**CITY OF ISSAQUAH
PLANNING DEPARTMENT
DEVELOPMENT COMMISSION**

STAFF REPORT

FILE NO.: Community Conference: PLN10-00064

PROJECT: **Hung Do Retail Development**

Sheet Title:
 BUILDING #1
 EXTERIOR ELEVATIONS

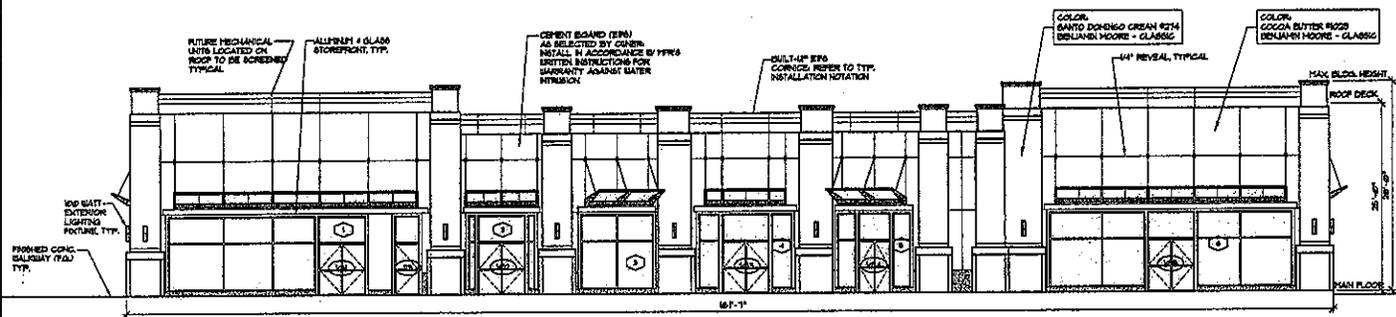
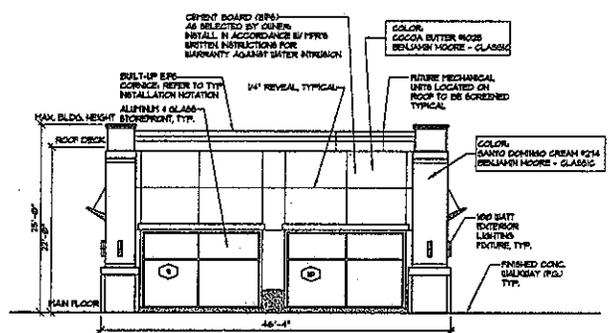
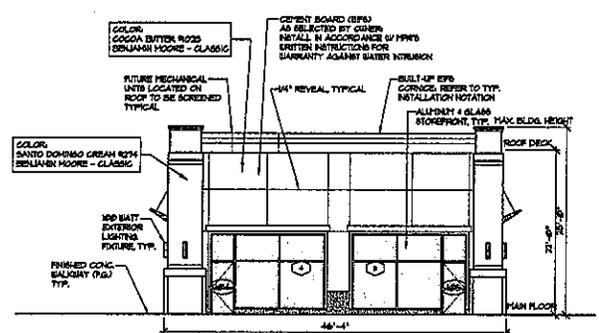
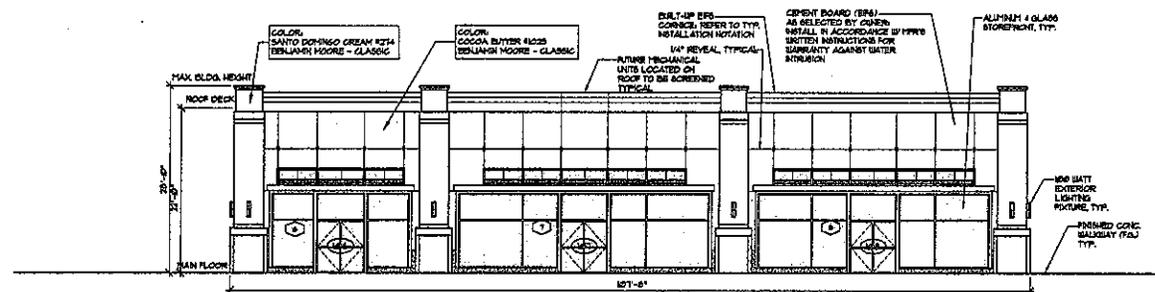
- a) **General Design:** Sheets 3.1 and 3.2 show the proposed building elevations. The following suggestions are offered relating to issues brought up during the review of the application that can be incorporated into the design. The building elevations show fairly well modulated and proportional massing that appears to reflect a traditional storefront appearance. However, it will be important to understand the specific design elements including the materials, colors, texture, and modulation details to establish whether this is an acceptable design or an outstanding design. For example, to establish a more traditional storefront appearance, the windows should stop at approximately 18" – 24" above grade instead of extending fully to the ground. This would establish the traditional design theme of a building base, middle and cap. This theme is shown on the adjacent cement board siding surrounding the windows. More materials should be considered to differentiate from the cement board (EIFS) covering most of the building now. For example, can the base and top be clad in a different material or texture, such as brick for example?

The drawings show angled awnings on the buildings that will offer some protection for pedestrians and design interest. It appears that some awnings extend a couple feet from the building at an angle perhaps for design accent more than pedestrian cover. Where there will be pedestrian activity, full awnings or canopies should be installed. Is it possible to add windows above the awnings while maintaining proportionality in the design and keeping sufficient wall signage space?

- b) **Mechanical Screening:** Rooftop mechanical equipment is not shown on the rooftop of the elevations; however, it is appreciated that a note is on the plans acknowledging the need to screen roof top equipment. As equipment is installed, the equipment will need to be screened with a material and color that is compatible with the building if it extends beyond the parapet wall of the roof.

MONUMENT SIGN
 SCALE: 1/4" = 1'-0"

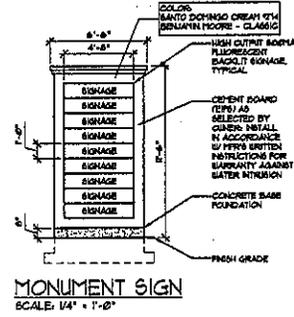
- c) **Signage:** Sheet 3.2 shows the elevation of the monument sign proposed at the corner of NW Sammamish Road and 221st Place. IMC Section 18.11.220.B "Multibusiness Development" states "A monument sign shall not exceed 10 feet in height and 100 square feet total for all faces with a maximum of 50 square feet for any one face. For retail development with four or more tenants, at least twenty-five percent of each face shall identify the development. The panels must be a minimum of 14" high with letters of at least 8" high. It appears that the proposed sign can meet the Sign Code requirements but the applicant will need to clearly show this on the sign permit application. Some combinations of wall, awning, canopy, or pedestrian signs are also anticipated with each tenant space, so the building elevations should be designed to anticipate such signage that is integrated with the architecture.
